# UNITED STATES PATENT AND TRADEMARK OFFICE

APPLICATION NO.	FILING DATE	FIRST NAMED INVENTOR	ATTORNEY DOCKET NO.	CONFIRMATION NO.
10/552,097	02/21/2006	Leung Choi Chow	2733.35US01	4192
24113 7590 10/06/2008 PATTERSON, THUENTE, SKAAR & CHRISTENSEN, P.A. 4800 IDS CENTER 80 SOUTH 8TH STREET MINNEAPOLIS, MN 55402-2100				
EXAMINER MITCHENER, JOSHUA J				
ART UNIT		PAPER NUMBER		
3644				
MAIL DATE		DELIVERY MODE		
10/06/2008		PAPER

### Office Action Summary

### DETAILED ACTION

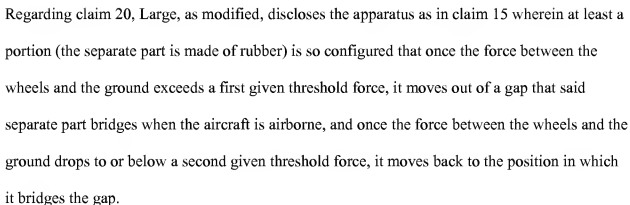
Roth discloses it is known to have a separate part on both sides of the wheel with a first surface in contact with the tire (see figure below), the second surface in contact with the rim (17,23,35,32,34) and third surface extending across the gap on an aircraft wheel (see figure below) wherein the separate part is flexible and made of rubber (col 2, line 21) thus deformable and capable to be moved manually.

Regarding claim 33, Large, as modified, discloses the apparatus as in claim 15 wherein the first surface follows the shape of the tire (see figure above).

Regarding claim 34, as best understood, Large, as modified, discloses the apparatus as in claim 15 wherein the first surface follows the shape of the wheel (see figure above).
